**Re: Rapiscan AIT System Radiation Survey Reporting**

<b>Rapiscan</b> systems	Secure 1000 Radiation Emission Measurement	FORM R-0646-1 (Single Pose)
----------------------------	--	--------------------------------

## R-0646-1 Addendum (Documentation Errors)

Product Name	Secure 1000SP (Single Pose)
Serial Number	<b>S51011006</b>
Radiation Emission Measurement	Radiation Survey Dated: 08/10/2010
RSO Initials	[REDACTED]

1. In Beam Dose Measurement: Survey Table. 1

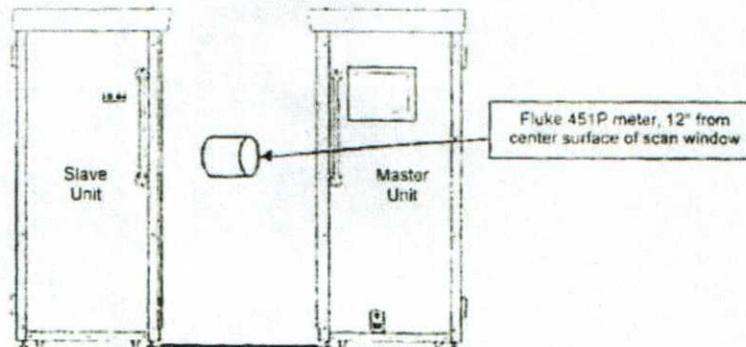
1. Technician indicated scan time as 7 seconds. Correct scan time is 3 seconds.
2. TABLE 1: Incorrect presentation of data in Column 3 for Measured Exposure. Indicated values are 13uR and 17uR. Corrected values are 1.3uR and 1.7uR.
3. TABLE 1: Incorrect presentation of data in Column 6 for Effective Dose. Indicated values are 3.25 uRem and 4.25 uRem. These figures were stated based on incorrect math calculations. Corrected values, per RSO calculations, are .747 uRem and .977 uRem. RSO corrected effective dose based on Measured Exposure as captured during the field survey.
4. TABLES 2 and 3: Incorrect presentation of data in Column 6 for Dose Equivalent. Indicated values are 2.5 uRem. The correct value should be 1.8 uRem.

The service technician should attend refresher training.

The corrected data indicates this system was operating within expected parameters. No re-survey is required for this system.
